# Access Compliance Report

## Public Rights-of-Way

### (Curb Ramps)

Intersection ID: 44780	Main Street: SESSIONS_ST	Cross Street: SILVER_CRESCENT_DR	Location: NW
ADA ID: 28AC0A1943EF	Ramp Type: PerpDiag	Initial Pass/Fail: Fail	Overall Compliance: No
Codes/Mitigation Info/Possible Solution		Field Measurements/Component Compliance	
Severity Score: 12.5

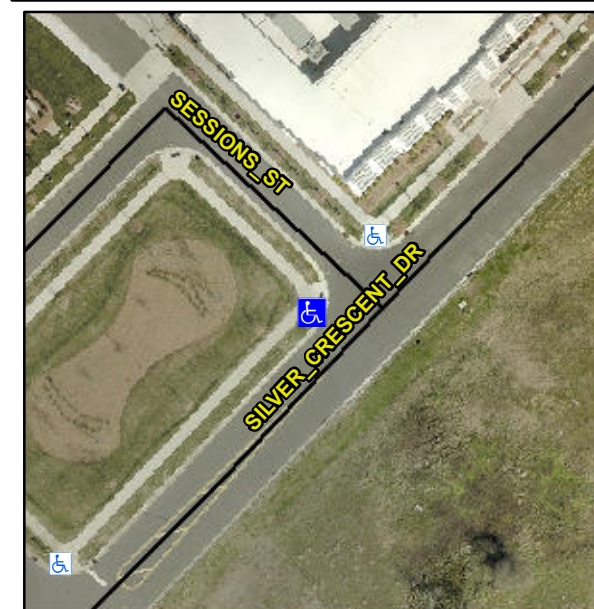
**R304.5.3**

Compliance	Description	Data	Compliance	Description	Data
N/A	Ramp Length (in)	89.0	Yes	Ramp Slope (%)	6.5
Yes	Ramp Width (in)	60.0	No	Ramp XSlope (%)	5.2
N/A	Flare Type LT	N/A	N/A	Flare Type RT	N/A
N/A	Flare Slope LT (%)	N/A	N/A	Flare Slope RT (%)	N/A
N/A	Flare Traversable LT?	N/A	N/A	Flare Traversable RT?	N/A
N/A	Landing Length (in)	N/A	N/A	DWS Provided?	N/A
N/A	Landing Width (in)	N/A	N/A	DWS Contrast?	N/A
N/A	Landing Slope (%)	N/A	N/A	DWS Length (in)	N/A
N/A	Landing X Slope (%)	N/A	N/A	DWS Full Width?	N/A
N/A	Landing Curb? (Y/N)	N/A	N/A	DWS Offset (in)	N/A
N/A	Shared Landing?	N/A			
N/A	Gutter Ponding?	N/A	N/A	Gutter Slope (%)	N/A
N/A	Gutter Lip Ht (in)	N/A	N/A	Gutter X Slope (%)	N/A
N/A	Painted X Walk1?	No	N/A	Painted X Walk2?	No
	X Walk 1 Direction	To SE		X Walk 2 Direction	To NE
N/A	X Walk 1 Width (in)	N/A	N/A	X Walk 2 Width (in)	N/A
	X Walk 1 Slope (%)	0.7		X Walk 2 Slope (%)	2.2
	X Walk 1 X Slope (%)	1.6		X Walk 2 X Slope (%)	1.3

**Remove & Replace Curb Ramp With Two New Directional Ramps or Equivalent.**
